RECEIPT DATE: 9/23/19 **ONSITE SEWAGE DISPOSAL SYSTEM** P 566379

PROPERTY ADDRESS: 12020 Hall Shop Road

SEPTIC SYSTEM INSTALLATION PLAN
 12020 Hall Shop Road
 Tax Map 14, Grid 12 F & G, Parcel 280
"KAZUE PROPERTY"
 5th Election District
 Howard County, Maryland

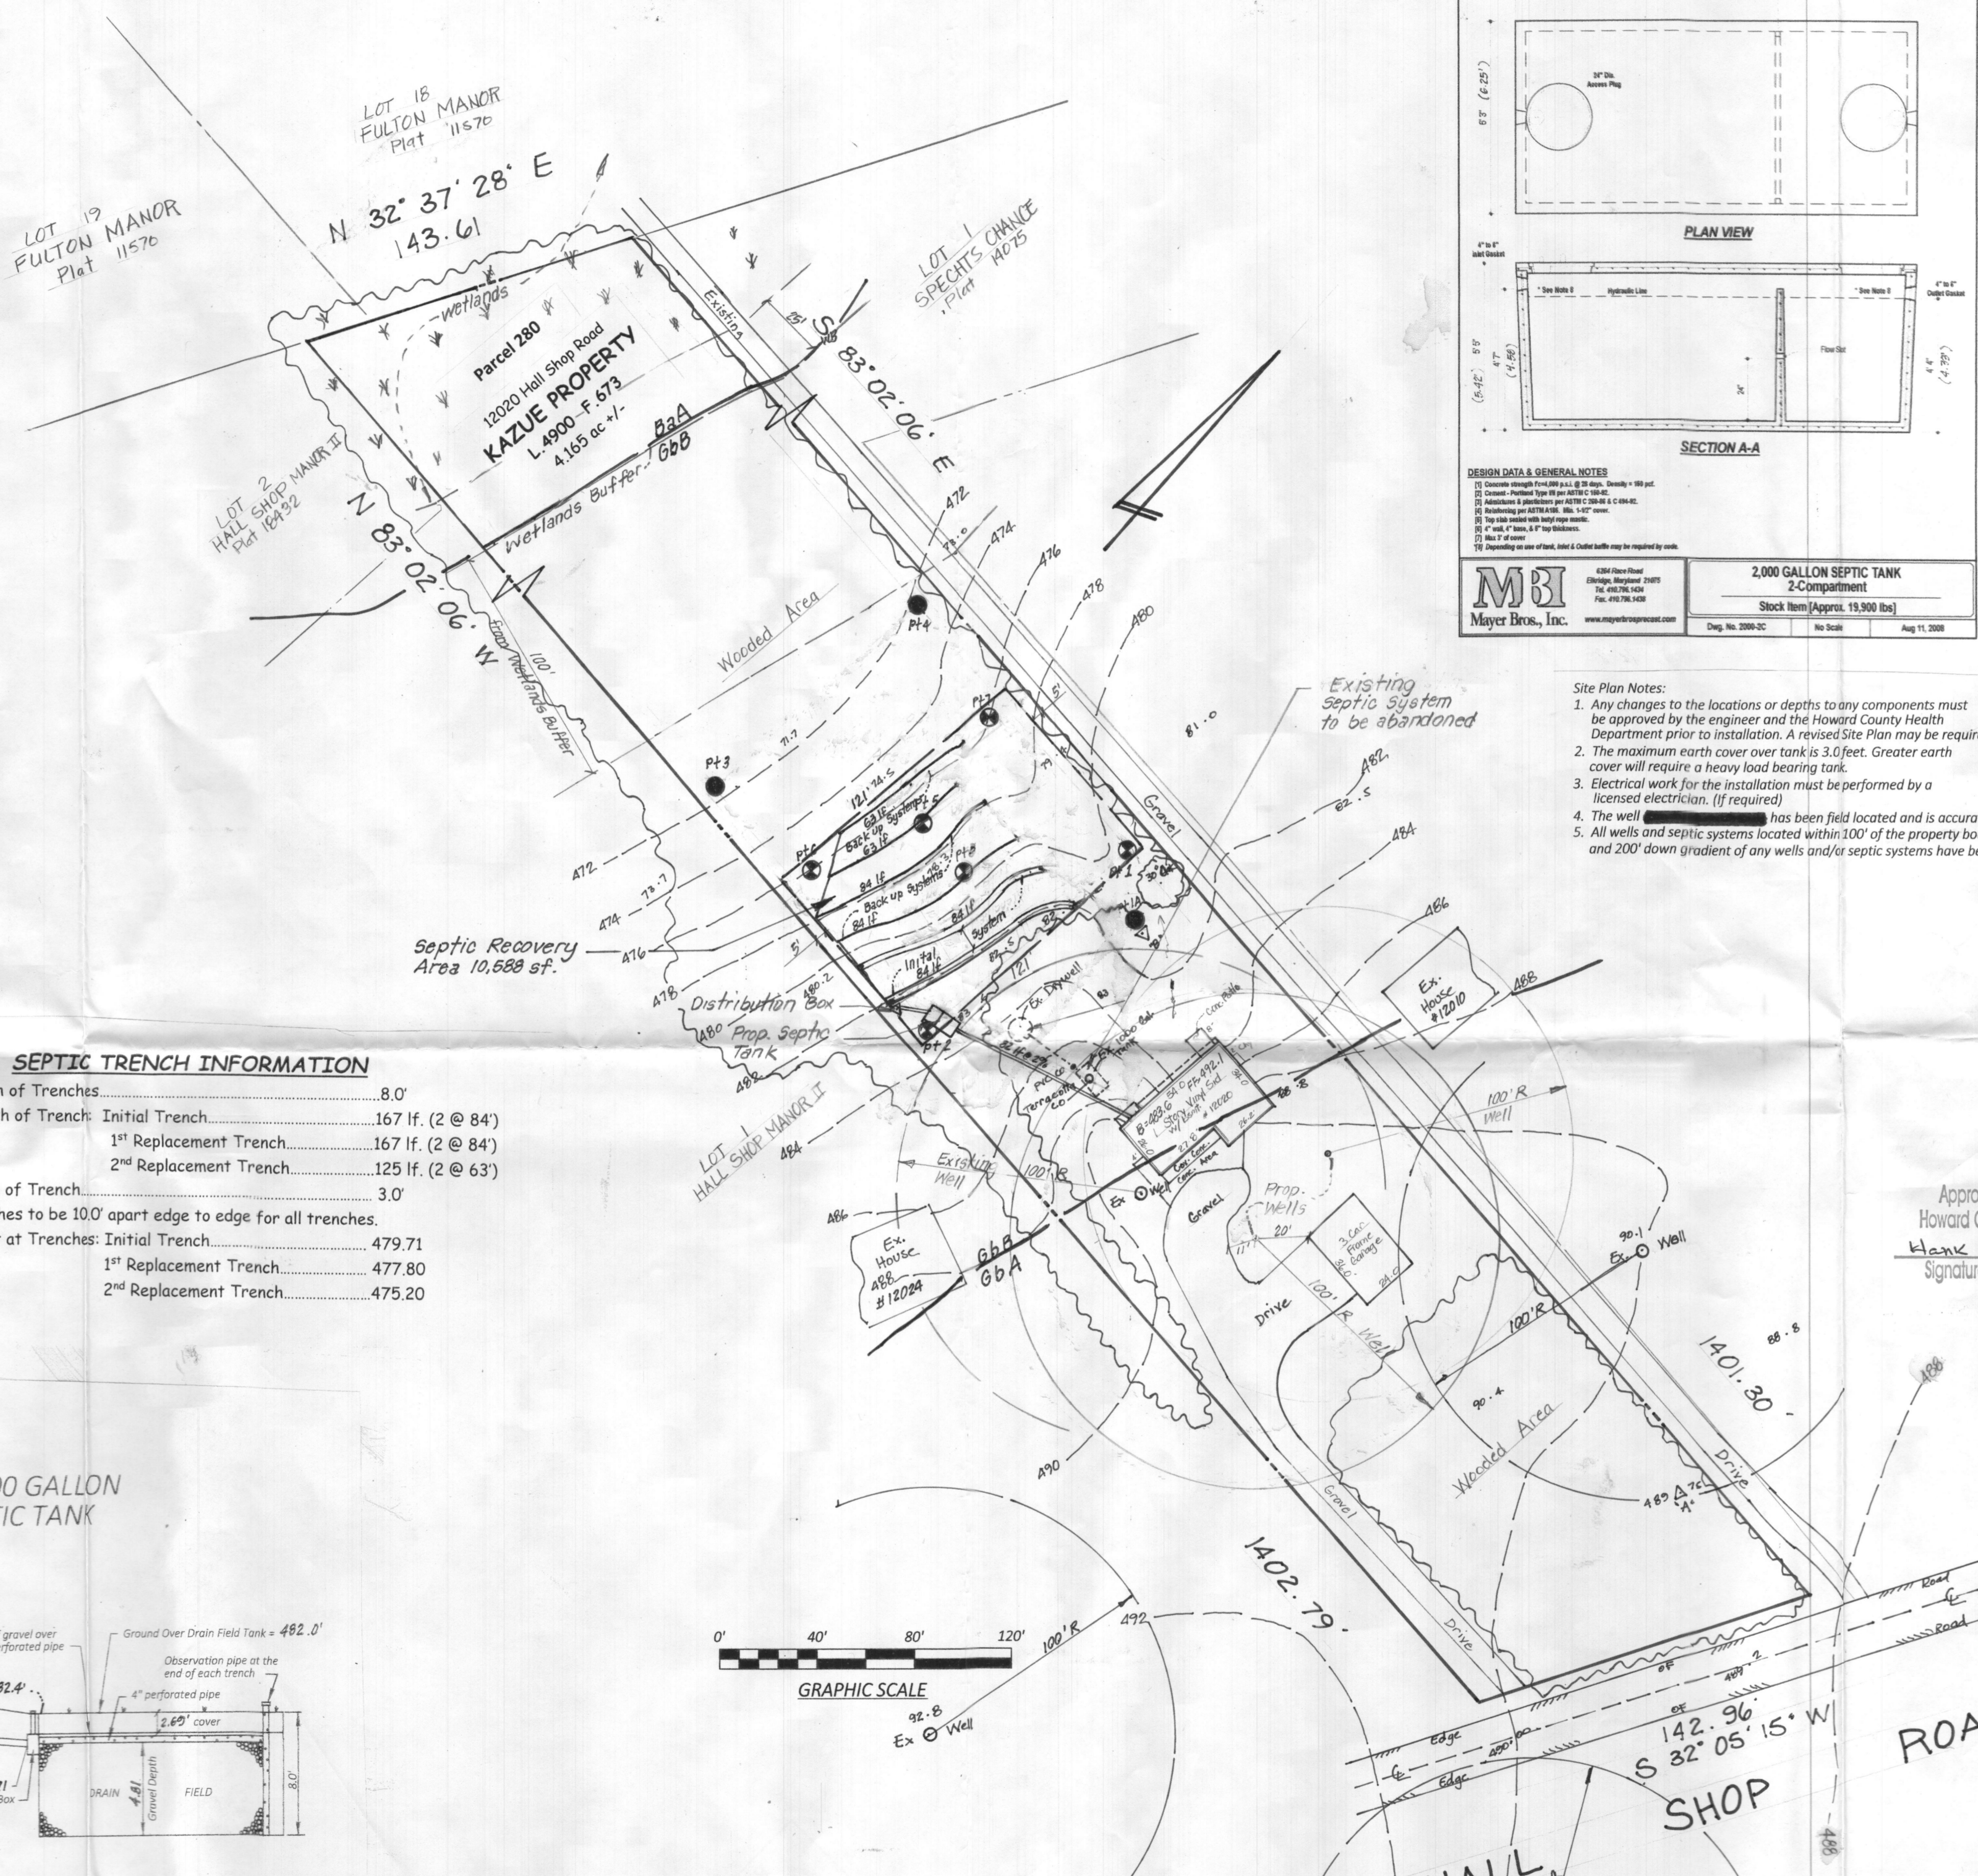
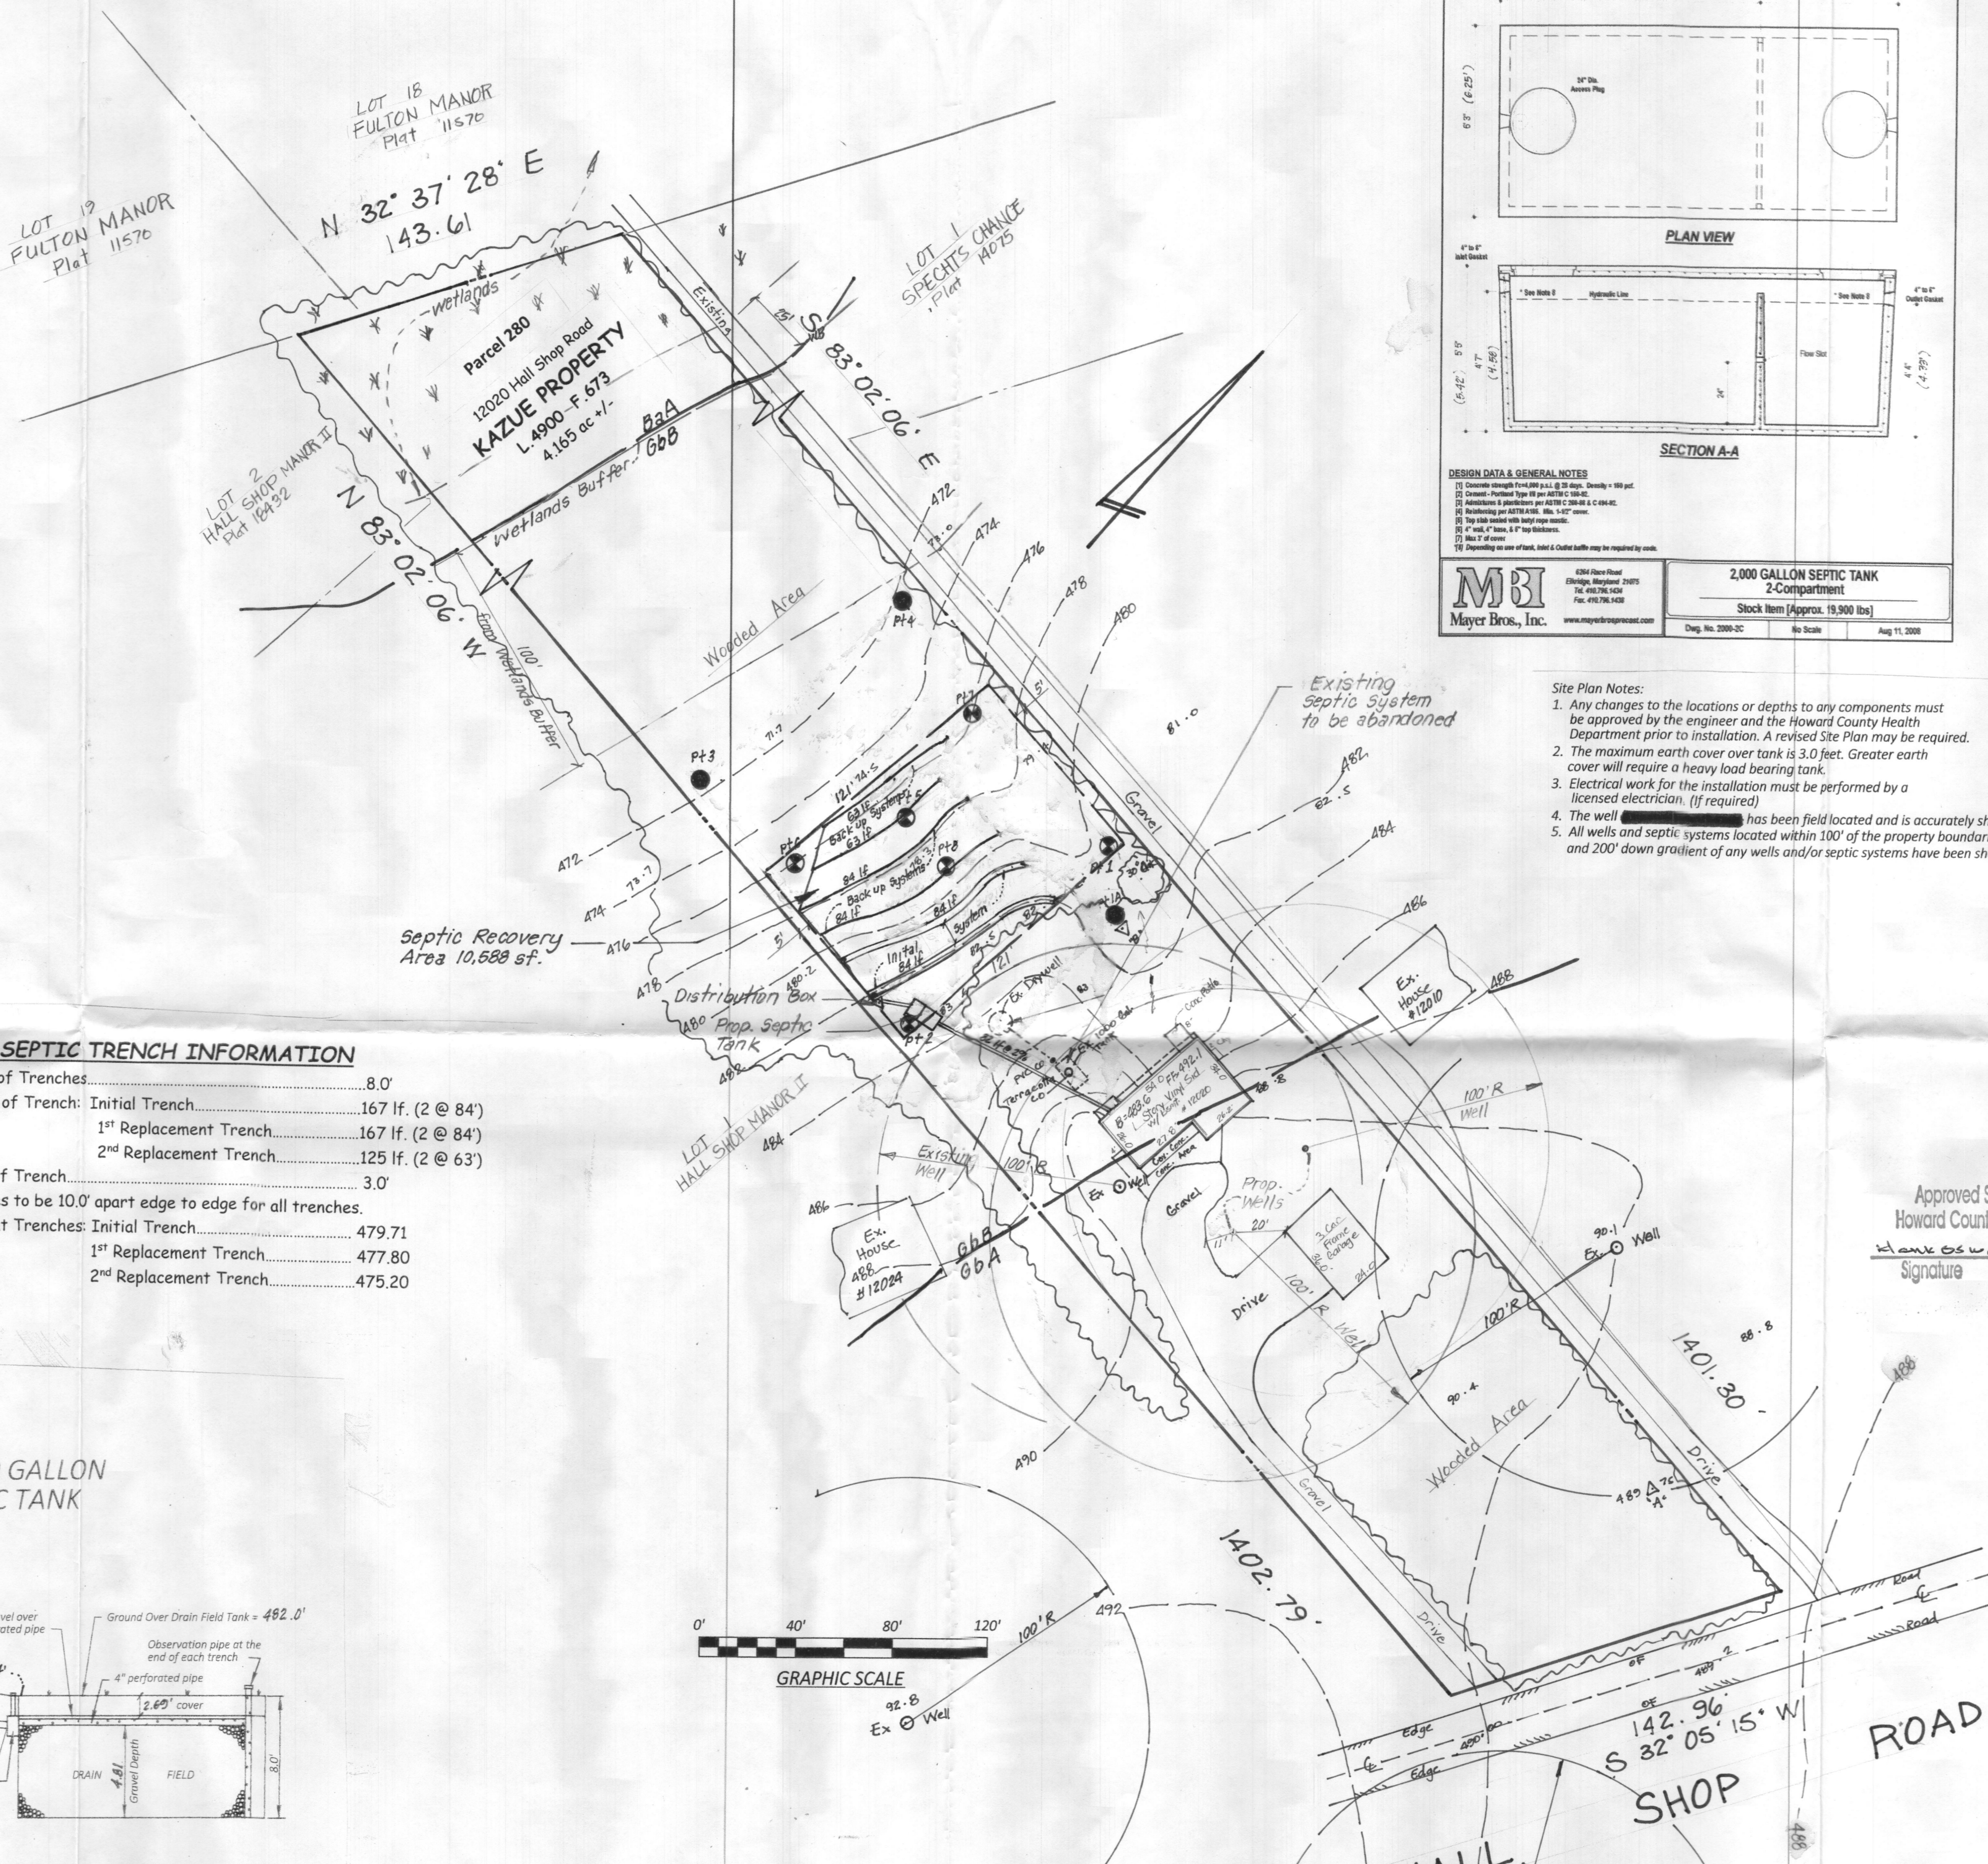
Upon co-review with my supervisor, we picked up on a discrepancy between the elevations on septic profile and the elevation over the line leaving the house on the drawing. The septic profile shows an approximate elevation of 484/485 and a ground elevation on the drawing at approximately 489/490. Are they planning to regrade the area? If so, then you will need to show it on the drawing. Additionally, how did you obtain the exact invert @ house elevation of 481.70? Did they excavate the line and measure down?

Good morning. I would like to redline two changes to the PC prior to submitting the plan for signature.

1. Strike line through "in conformance with the Master Plan of Howard County" in signature block.
2. Cut off SDA at ends of trenches to eliminate swale per last set of comments.
